RENESAS TECHNICAL UPDATE

Product Category	MPU/MCU		Document No.	TN-RX*-A0227A/E	Rev.	1.00
Title	Errata to User's Manual: Hardware Regarding the I ² C-bus Interface (RIIC)		Information Category	Technical Notification		
Applicable Product	RX130 Group, RX13T Group, RX230 Group, RX231 Group, RX23W Group, RX23E-A Group, RX65N Group, RX651 Group, RX66T Group, RX72T Group, RX66N Group, RX72N Group, RX72M Group	Lot No.	Reference Document	User's Manual: Hardware for applicable products (see the table at the last page)		
		All

This document describes corrections to the “I²C-bus Interface (RIIC)” chapter in User's Manual: Hardware for the applicable products.

Figure 29.28 Set/Clear Timing of the AASy and DID Flags during Reception of Device-ID Address

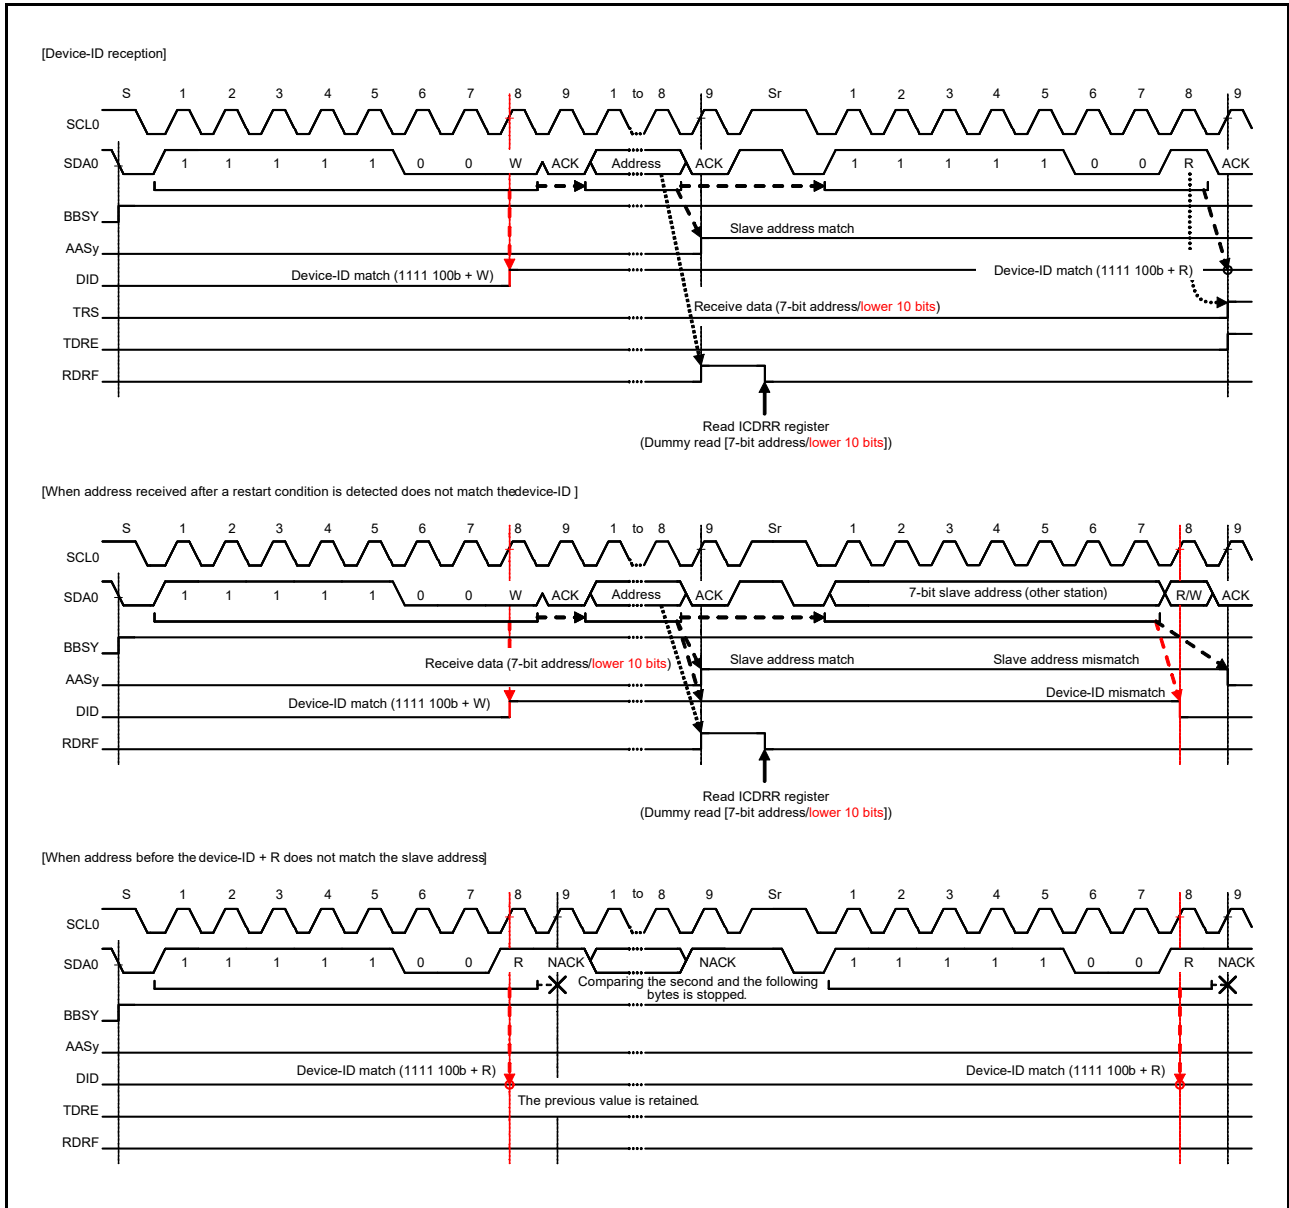
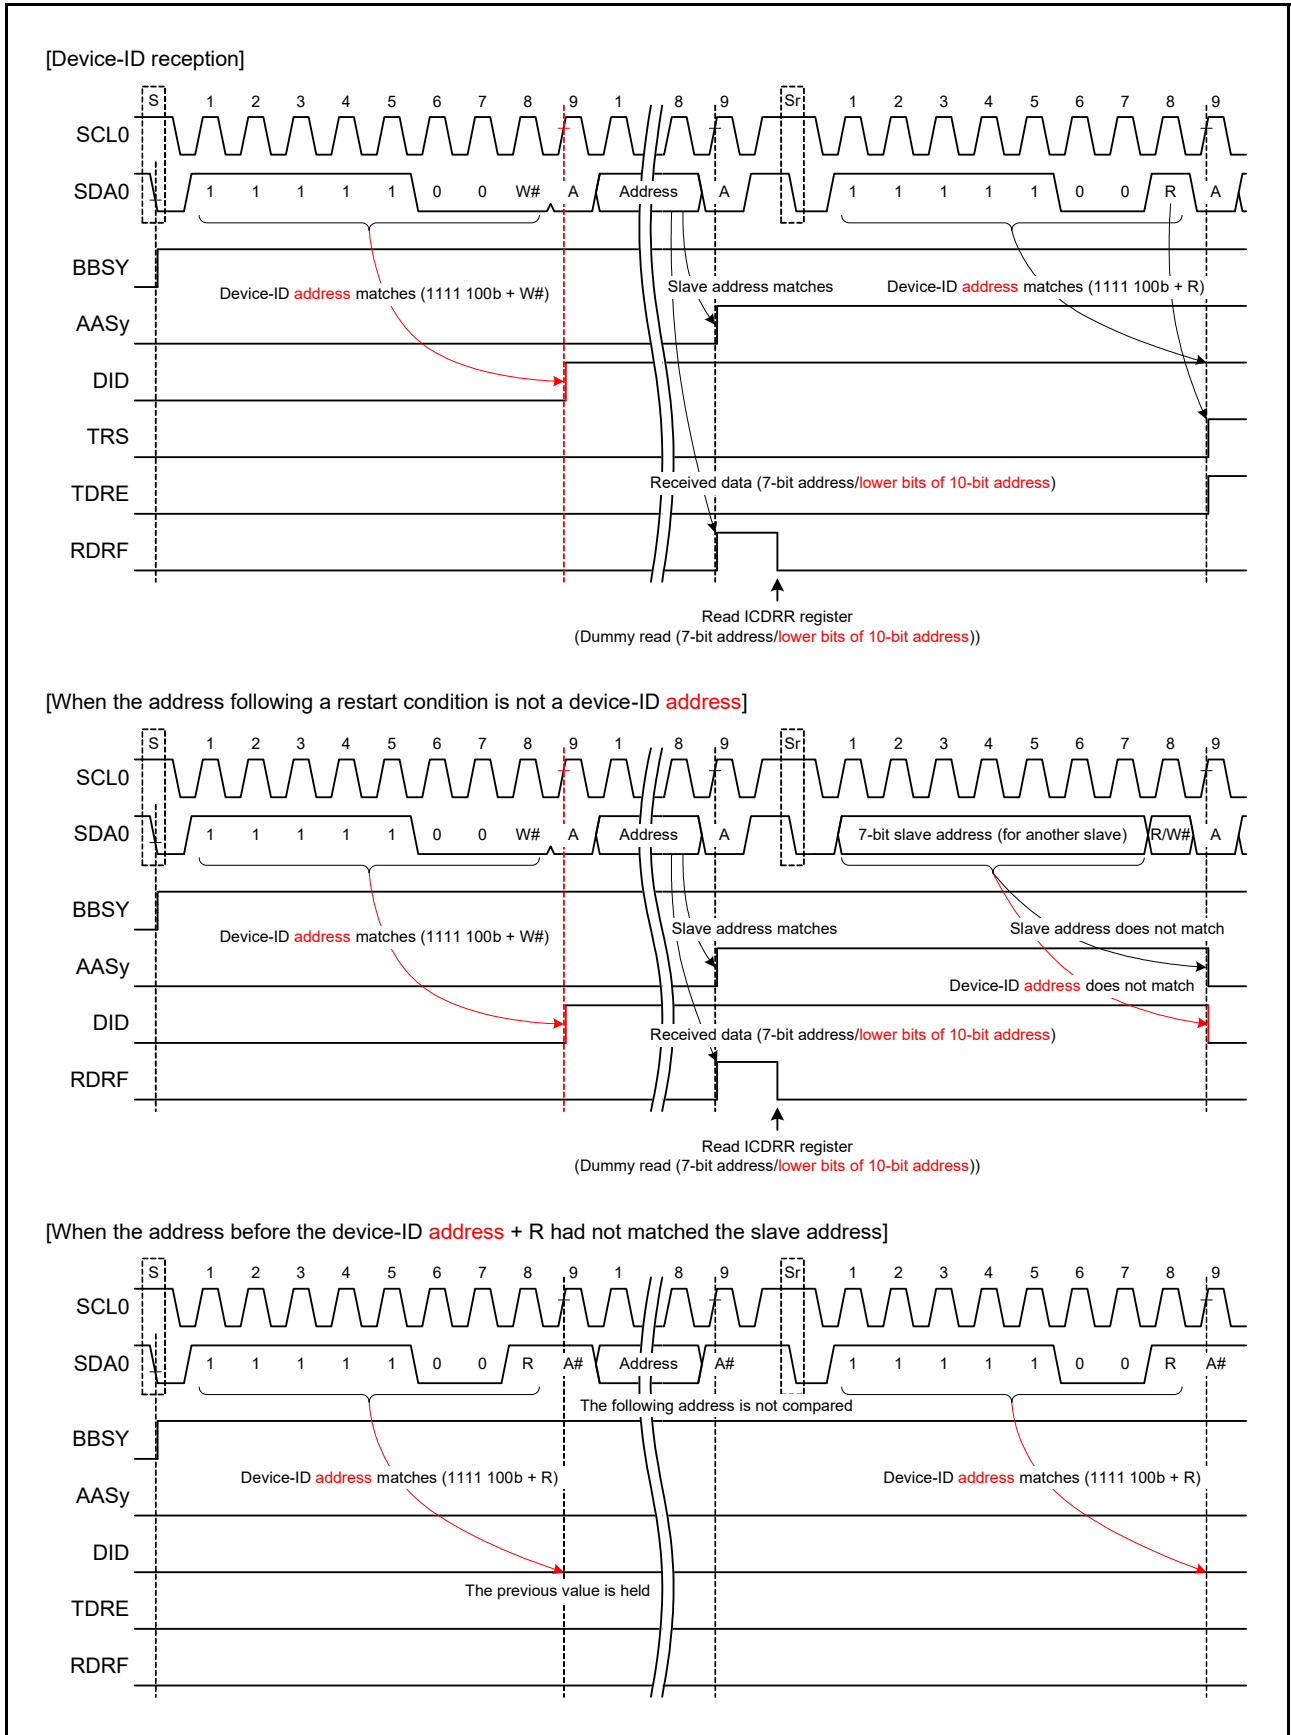
Figure 29.28 in section 29.7.3, Device-ID Address Detection is corrected as follows.

Figure 29.31 Suspension of Data Transmission When NACK is Received (NACKF = 1)

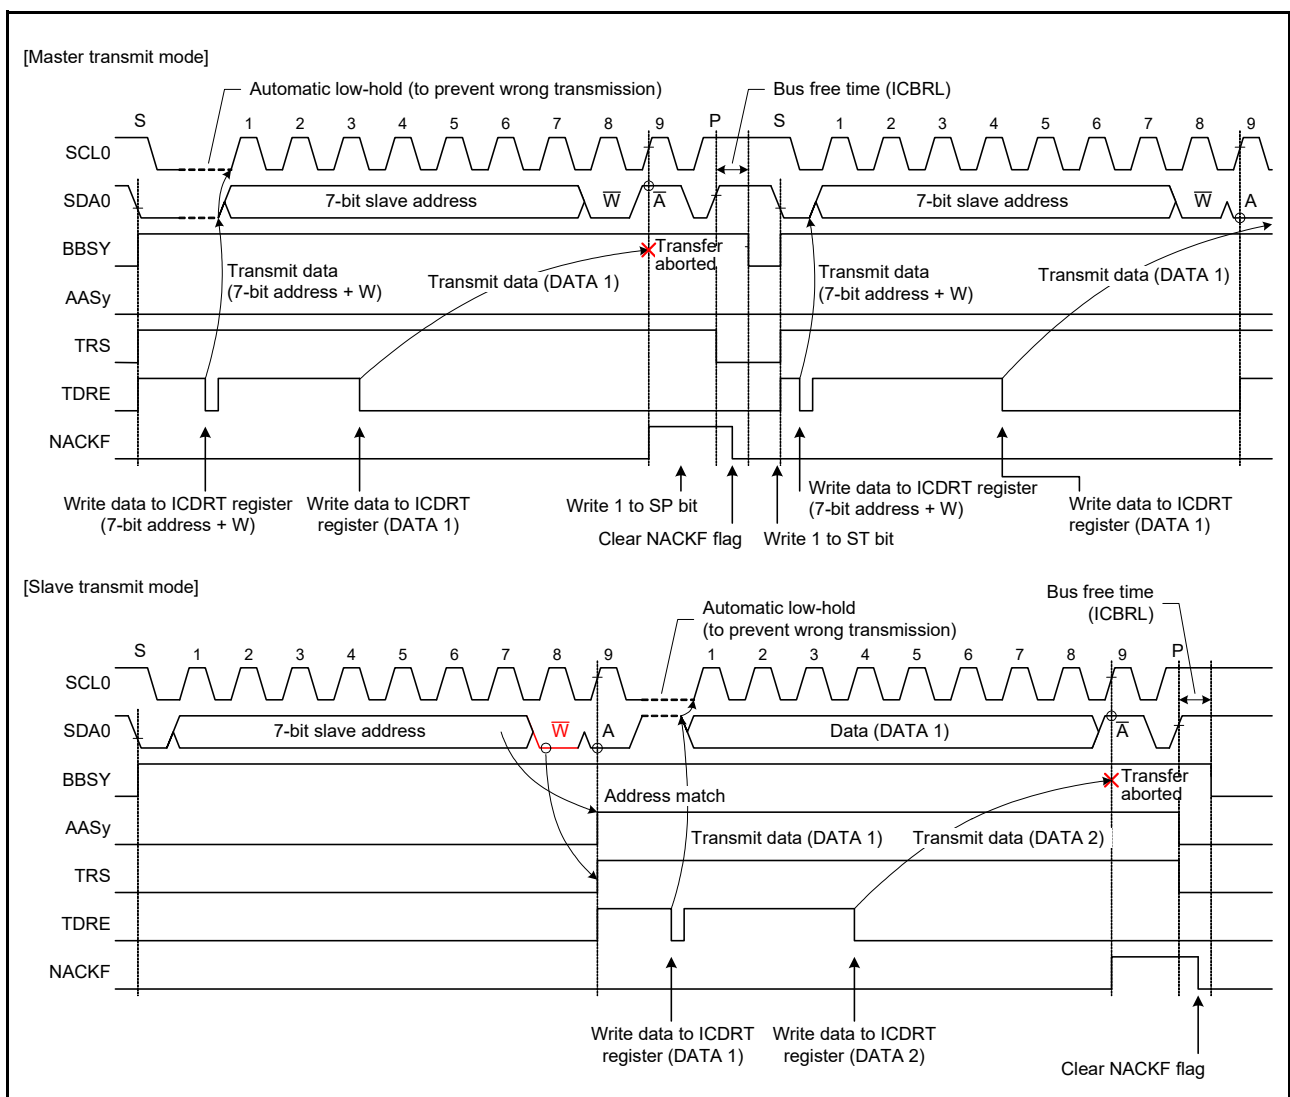
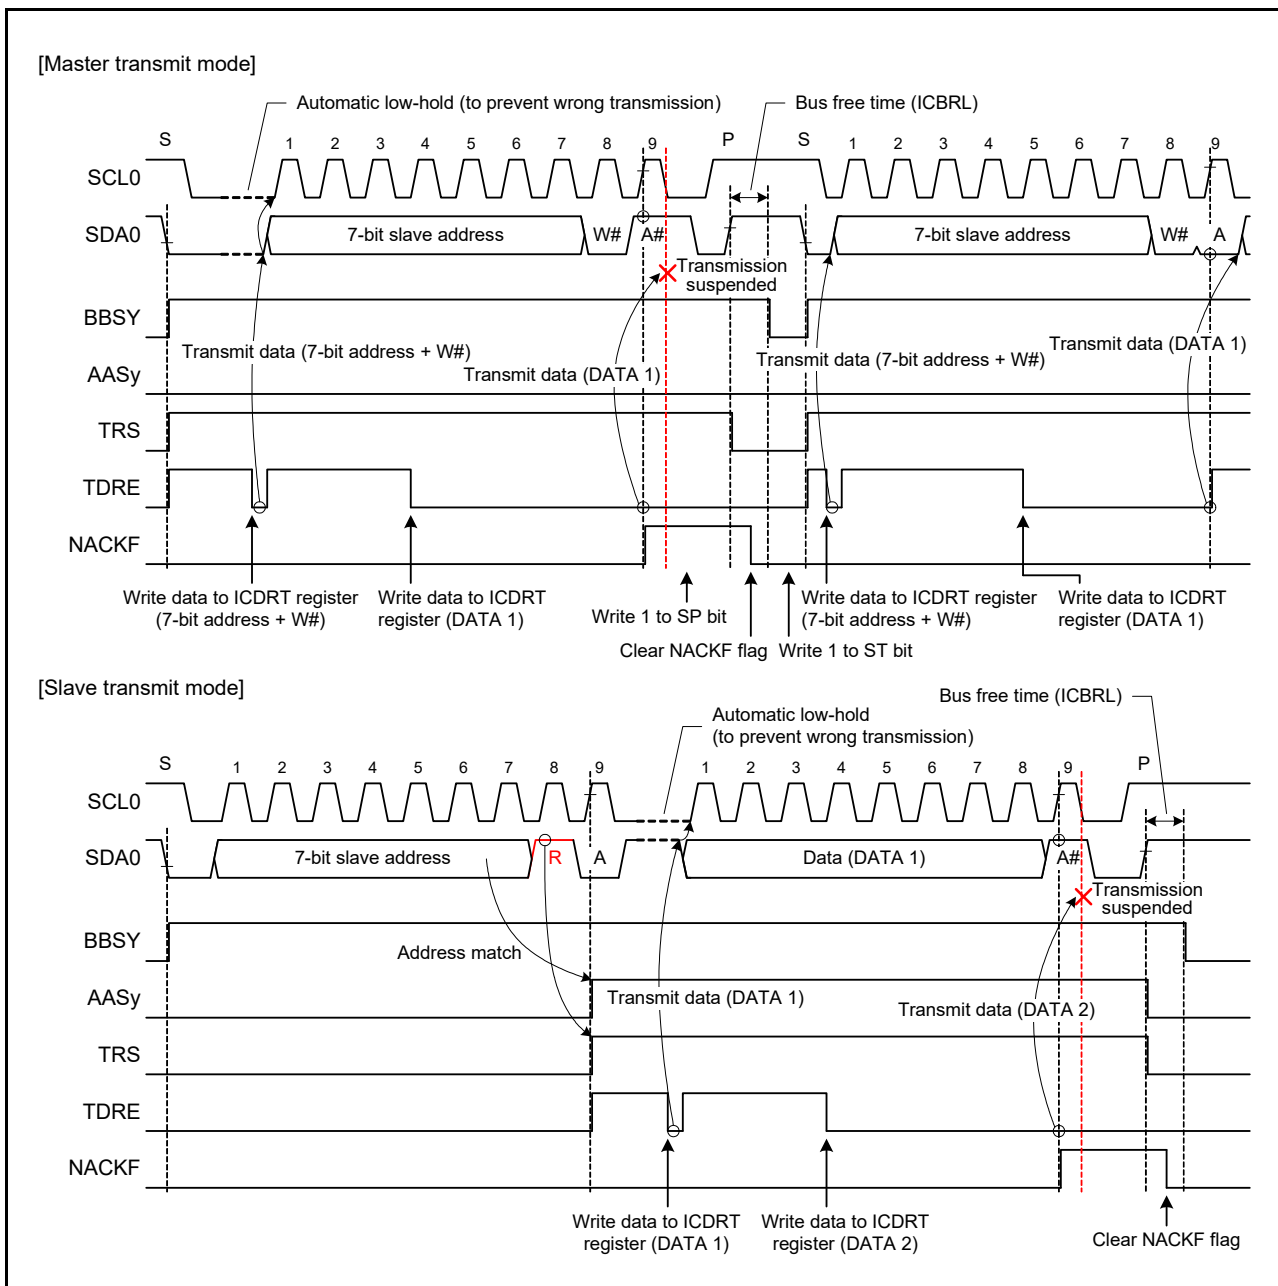
Figure 29.31 in section 29.8.2, NACK Reception Transfer Abort Function is corrected as follows.

Figure 29.40 Additional SCL Output Function (CLO Bit)

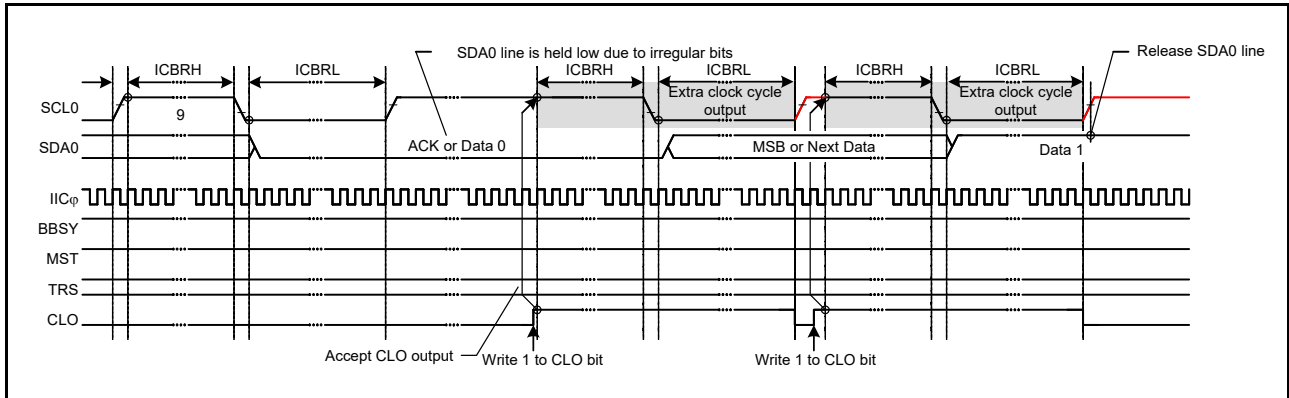
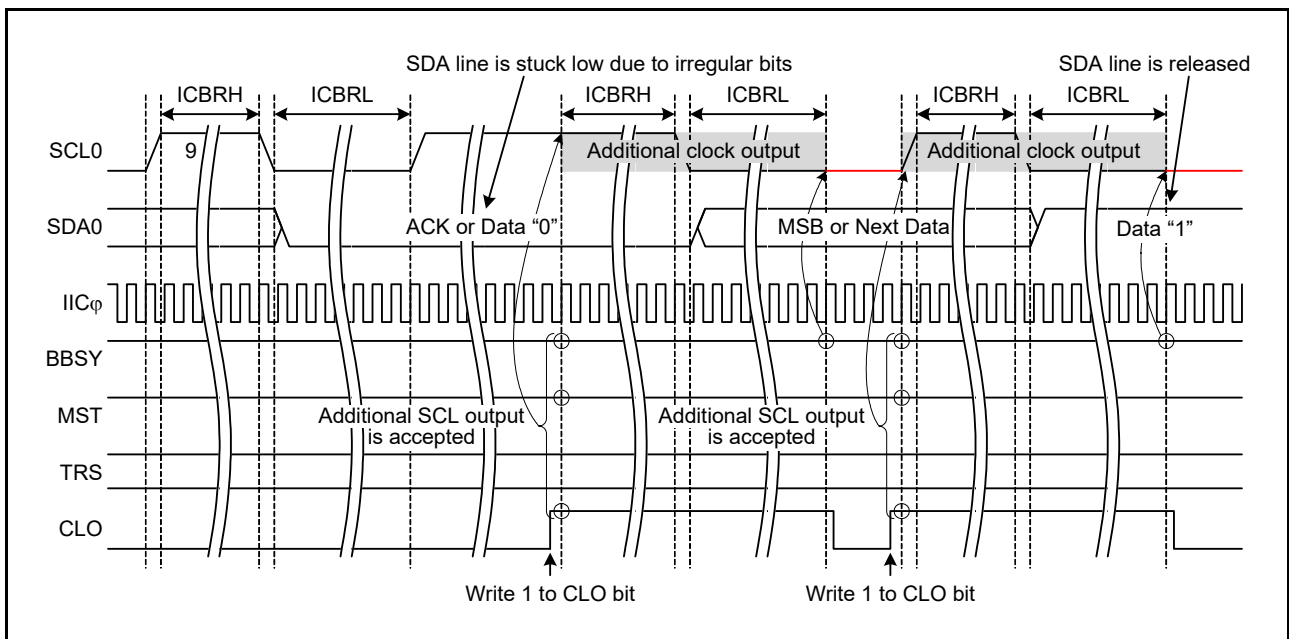
Figure 29.40 in section 29.11.2, Extra SCL Clock Cycle Output Function is corrected as follows.
